Intel[®] Celeron[®] Processor Specification Update

Release Date: December 2001

Order Number: 243748-039

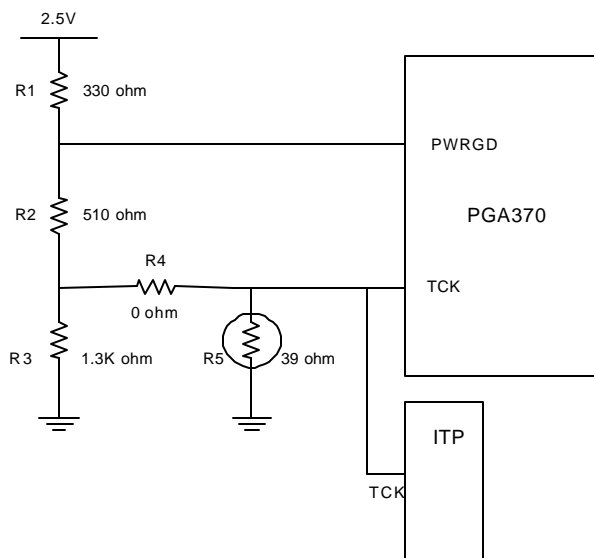
Implication: This issue can lead to intermittent system power-on boot failures. The occurrence and repeatability of failures is system dependent, however all systems and processors are susceptible to failure. In addition, the processor may fail to stop execution during the event of a valid THERMTRIP# assertion resulting in the potential for permanent processor damage.

Workaround: To prevent the risk of power-on boot failures or catastrophic thermal failures, a platform workaround is required. The system must provide a rising edge on the TCK signal during the power-on sequence that meets all of the following requirements:

- Rising edge occurs after Vcc_core is valid and stable
- Rising edge occurs before or at the de-assertion of RESET#
- Rising edge occurs after all Vref input signals are at valid voltage levels
- TCK input meets the Vih min and max spec as mentioned in EMTS

Specific workaround implementations may be platform specific. The following examples have been tested as acceptable workaround implementations.

Please note, the example workaround circuits attached require circuit modification for ITP tools to function correctly. These modifications must remove the workaround circuitry from the platform and may cause systems to fail to boot. Review the accompanying notes with each workaround for ITP modification details. If the system fails to boot when using ITP, issuing the ITP 'Reset Target' command on failing systems will reset the system and provide a sufficient rising edge on the TCK pin to ensure proper system boot.
